Access Compliance Report

(Curb Ramps)

Intersection ID: 16859	Main Street: ASHMORE_DR	Cross Street: MONROE_RD	Location: NE
ADA ID: 6663DFA1A2D2	Ramp Type: PerpDiag	Initial Pass/Fail: Fail	Overall Compliance: No
Severity Score: 33.75			
Codes/Mitigation Info/Possible Solution		Field Measurements/Component Compliance

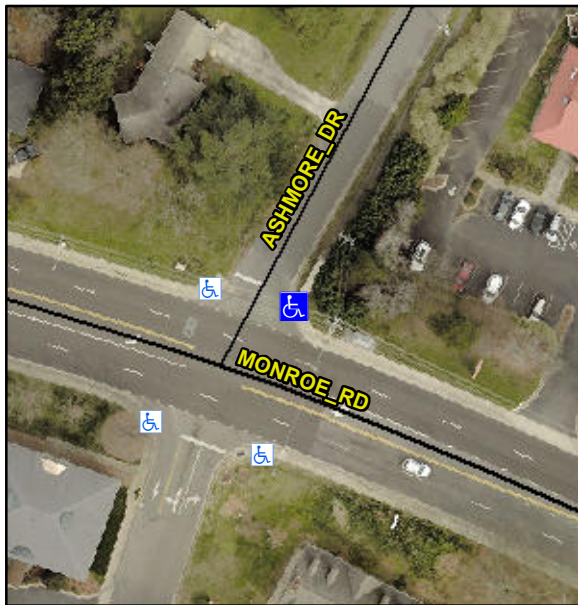
Remove & Replace Curb Ramp With Two New Directional Ramps or Equivalent.

R304.5.1, R304.2.2, R304.5.3

Compliance	Description	Data	Compliance	Description	Data
N/A	Ramp Length (in)	65.0	No	Ramp Slope (%)	8.7
No	Ramp Width (in)	38.0	No	Ramp XSlope (%)	6.0
N/A	Flare Type LT	N/A	N/A	Flare Type RT	N/A
N/A	Flare Slope LT (%)	N/A	N/A	Flare Slope RT (%)	N/A
N/A	Flare Traversable LT?	N/A	N/A	Flare Traversable RT?	N/A
N/A	Landing Length (in)	N/A	N/A	DWS Provided?	N/A
N/A	Landing Width (in)	N/A	N/A	DWS Contrast?	N/A
N/A	Landing Slope (%)	N/A	N/A	DWS Length (in)	N/A
N/A	Landing X Slope (%)	N/A	N/A	DWS Full Width?	N/A
N/A	Landing Curb? (Y/N)	N/A	N/A	DWS Offset (in)	N/A
N/A	Shared Landing?	N/A			
N/A	Gutter Ponding?	N/A	N/A	Gutter Slope (%)	N/A
N/A	Gutter Lip Ht (in)	N/A	N/A	Gutter X Slope (%)	N/A
N/A	Painted X Walk1?	No	N/A	Painted X Walk2?	No
	X Walk 1 Direction	To NW		X Walk 2 Direction	To SW
N/A	X Walk 1 Width (in)	N/A	N/A	X Walk 2 Width (in)	N/A
	X Walk 1 Slope (%)	2.2		X Walk 2 Slope (%)	10.7
	X Walk 1 X Slope (%)	4.1		X Walk 2 X Slope (%)	2.1
